MINUTES OF PREBID MEETING FOR TURNKEY CONSTRUCTION OF 2X50 MVA, 132/33 kV GIS AT EXISTING 220/132 kV AMINGAON GIS ON 16.08.2022

Minutes of Pre-Bid Meeting held on	O/o the MD, AEGCL, 1 st Floor, Bijulee Bhawan, Paltan Bazar, Guwahati-01 dated 16.08.2022
Name of the Project	North-East Special Infrastructure Development Scheme (NESIDS)
Funding Agency	Ministry of Development of North Eastern Region (MDoNER)
Name of the Work	Turnkey Construction of 2X50 MVA, 132/33 kV GIS at existing 220/132 kV Amingaon GIS
NIT No.	AEGCL/MD/Tech-868/Amingaon GIS/2020/NIT/22 Dated 29.07.2022

ASSAM ELECTRICITY GRID CORPORATION LTD.	DRAWING_TITLE
	SINGLE LINE DIAGRAM
220/132/33 KV AMINGAON GIS SUBSTATION

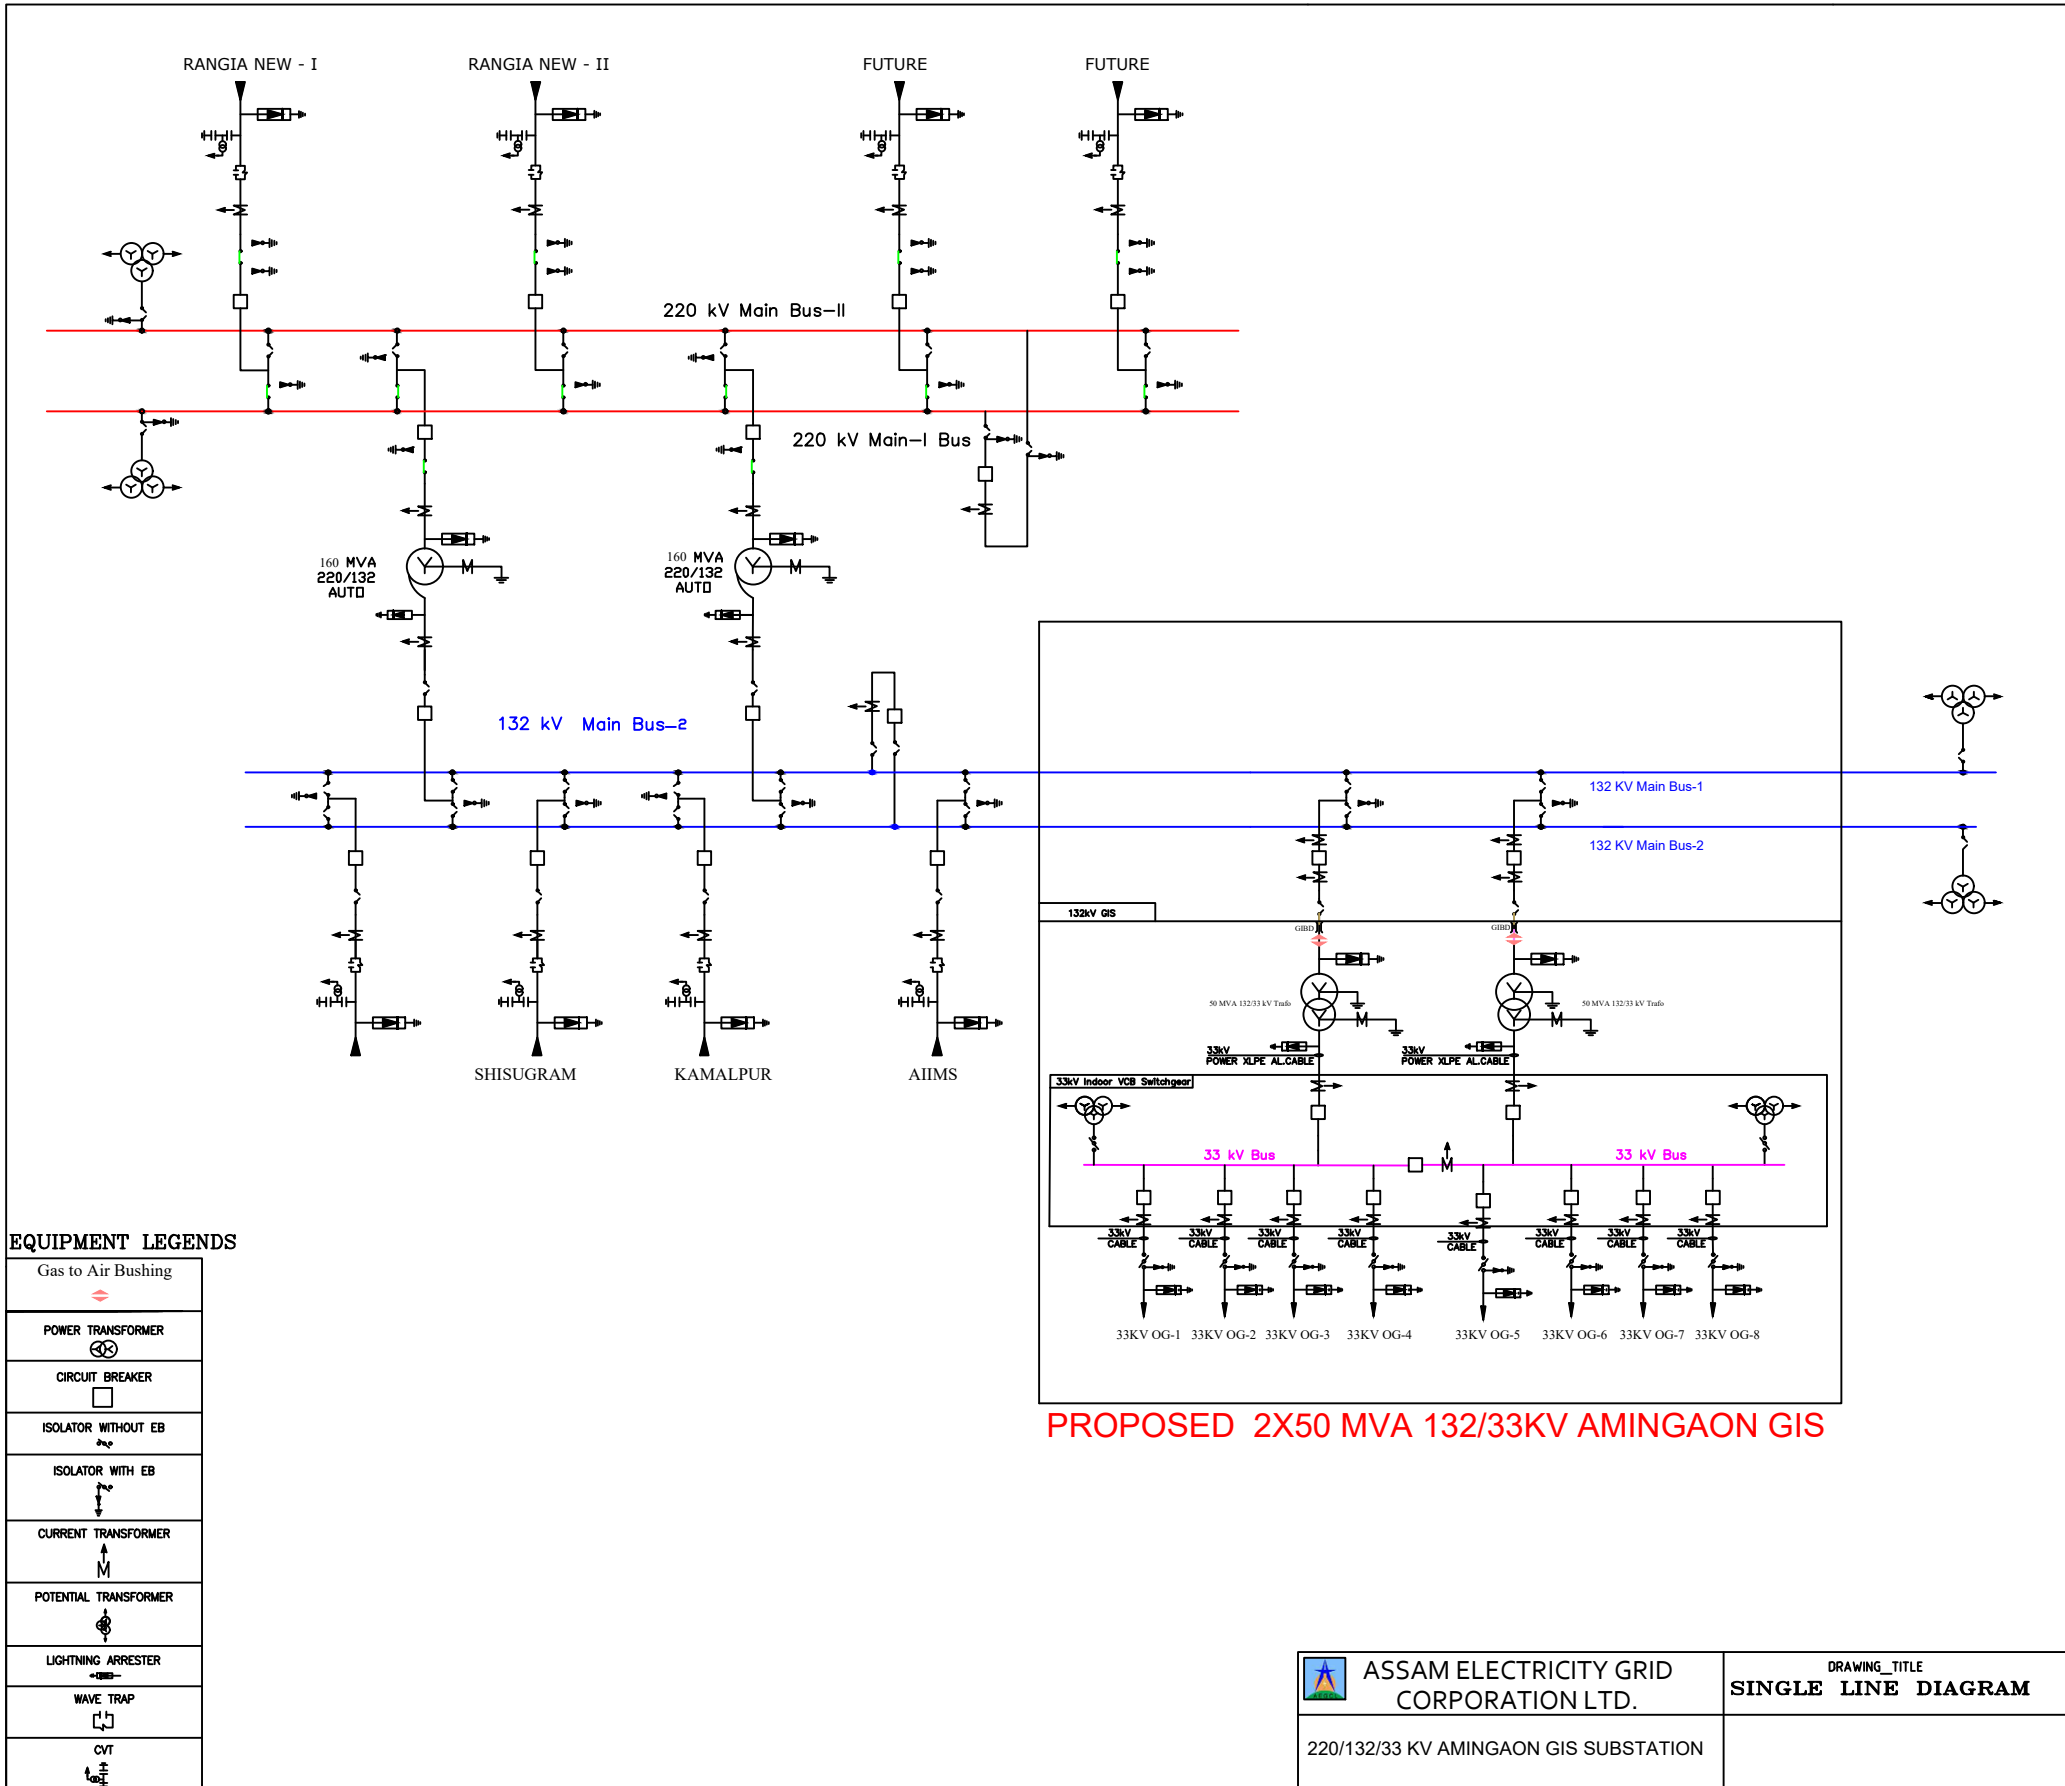
<p>106 Volume-II, Section-5, Clause-5.18.0</p>	<p>The panel should be type tested within 5 years of opening of tender from any of the following testing laboratory: CPRI/ ERDA/ KEEMA/ KERI/ PHELVA/ CESI/NABL accredited laboratory.</p>	<p>We request you to accept the type test validity as per the latest CEA guidelines i.e., validity of the type test shall be within 10 years of opening of the tender.</p>	<p>Accepted</p>
<p>107 Volume-II, Section-5,</p>	<p>As per this section we need to refer volume III for the Drawings related to 33 kV AIS panels.</p>	<p>We request AEGCL to provide the SLD for 33 kV AIS portion as the same is not available along with the Bid.</p>	<p>Attached with pre bid MOM</p>
